COUNCIL ASSESSMENT REPORT – MODIFICATION APPLICATION

HUNTER AND CENTRAL COAST REGIONAL PLANNING PANEL

PANEL REFERENCE & DA NUMBER	PPSHCC-362 DA2019-102(3)	
PROPOSAL	Section 4.55(2) to: • modify the landscaping screening requirements, • remove references to permanent amenities building and • remove the requirement to seal part of the internal access road.	
ADDRESS	Lot 12 DP 1042612	
APPLICANT	Stroud Agricultural Company Pty Ltd	
OWNER	Stroud Agricultural Company Pty Ltd	
MOD LODGEMENT DATE	7 April 2025	
ORIGINAL DA DETERMINATION DATE	6 May 2020	
APPLICATION TYPE	Modification Application under Section 4.55(2)	
CIV	\$11,960,115 (excluding GST)	
TOTAL SUBMISSIONS	One (1)	
DOCUMENTS SUBMITTED FOR CONSIDERATION	Attachment A Attachment B Attachment C Attachment D Attachment E Attachment F Attachment G Attachment H	Draft Conditions Physical Comment correspondence Proposed plans Landscape Plan Photomontage Shading Analysis - current Shading Analysis 2 - proposed Submission
RECOMMENDATION	Approval	
DRAFT CONDITIONS TO APPLICANT	No

SCHEDULED MEETING DATE	7 October 2025	
PREPARED BY	Donna Watson Senior Land Use Planner	
DATE OF REPORT	13 October 2025

Figure 2 – Plan showing the height of tallest solar panel.

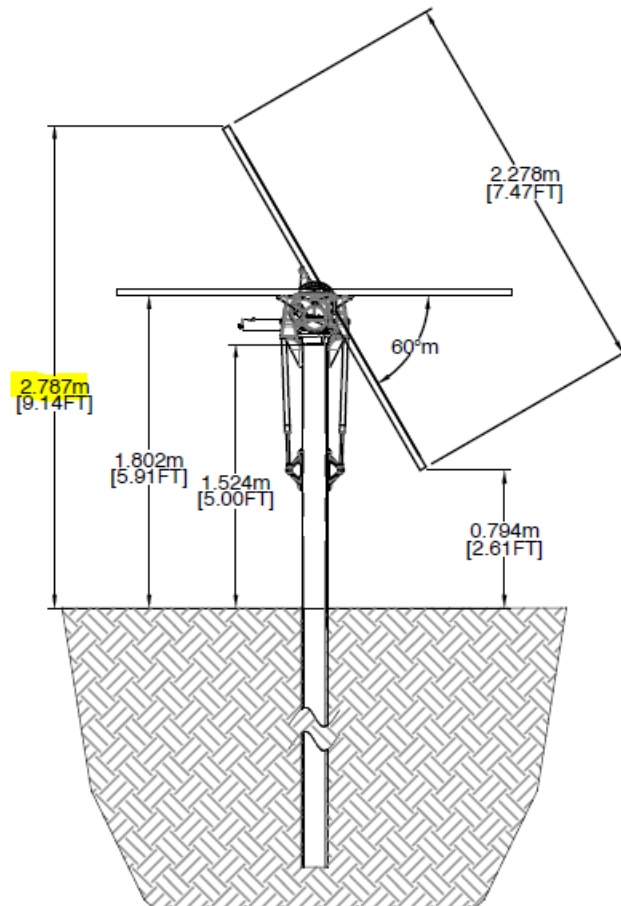
The applicant has advised that the tallest solar panels have an overall height of 2.78m being from the ground to the top of the panel (See Figure 2 below). In this regard, the panels will be adequately screened by 4m high vegetation.

Figure 3 – Location of submitter in relation to the site.

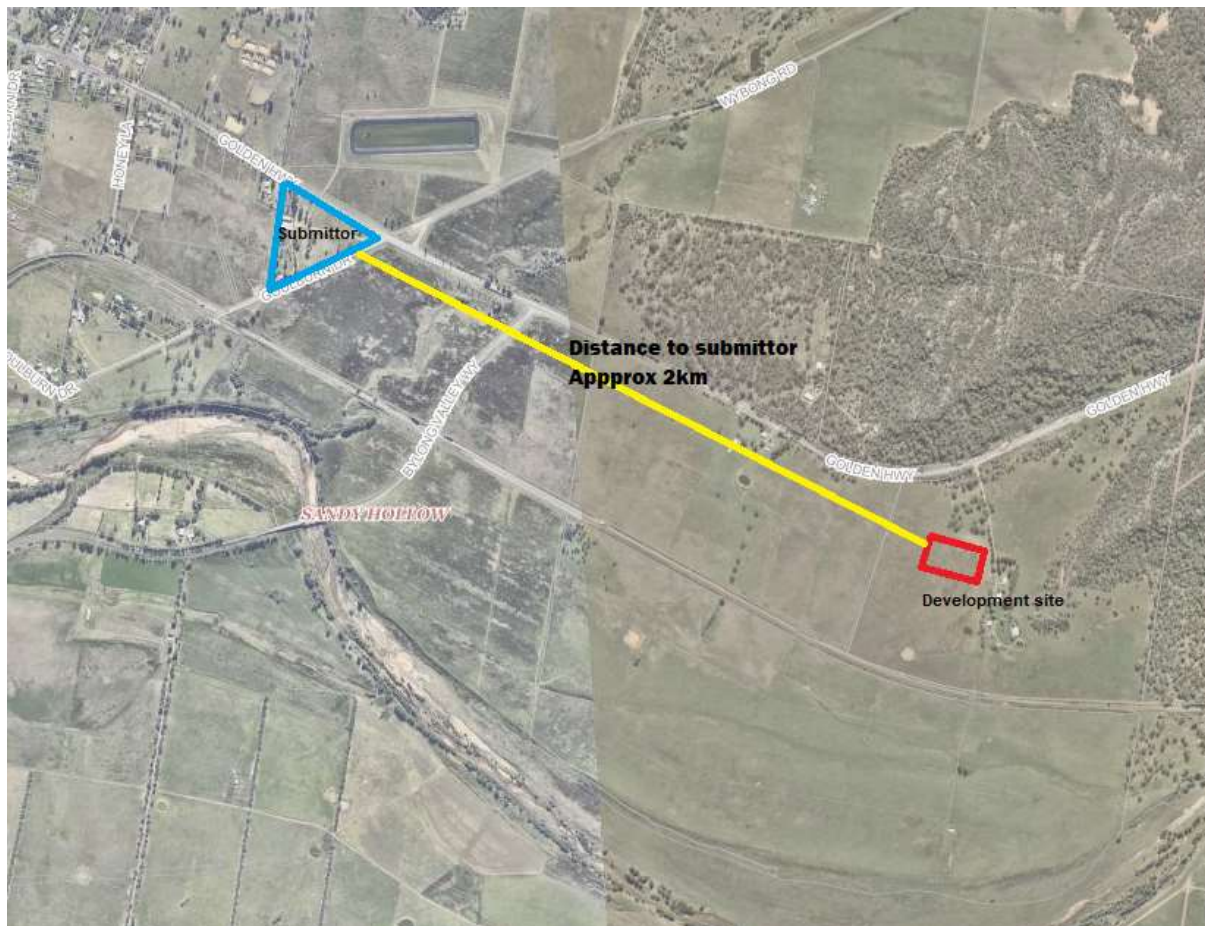
The original Visual Impact Assessment 2019, included a view point from this location and the recommended mitigation measures:

Consultation should be undertaken with the sensitive receivers in this area. Should additional screening be necessary, a landscape plan should be developed in consultation with the sensitive receiver with the aim to obstruct the view of the solar farm. This should be relatively easy to achieve as the topography between the proposal site and sensitive receiver is relatively flat and any plantings would be very effective.

Figure 4 – Extract from Landscaping plans showing aerial view of proposed landscaping strip.

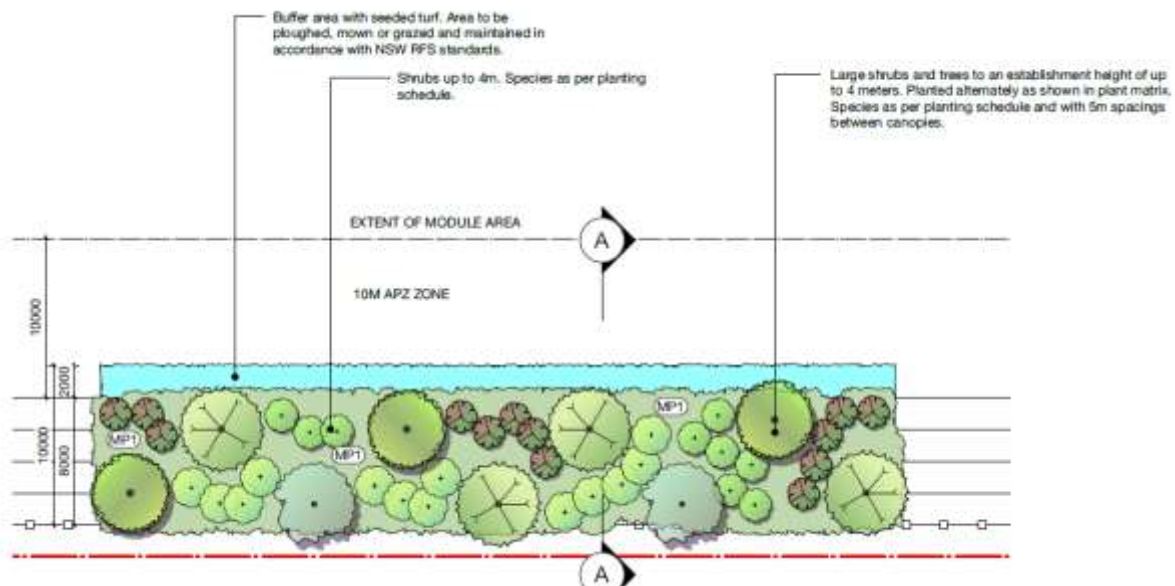
The modification is requesting a reduction to the height of landscaping from 8m in height to 4m along the western and northern boundaries of the development site. In addition to the reduction in landscaping height along the western development boundary, the applicant is requesting a change to the width from 10m of landscaping to 8m and a 2m grassed strip, as seen below.

From a review of the original Visual Impact Assessment and photomontages, the reduction in tree height to 4m and width to 8m will still provide adequate screening affected receivers. Council staff have no objection to the reduction in tree height along the western development boundary.
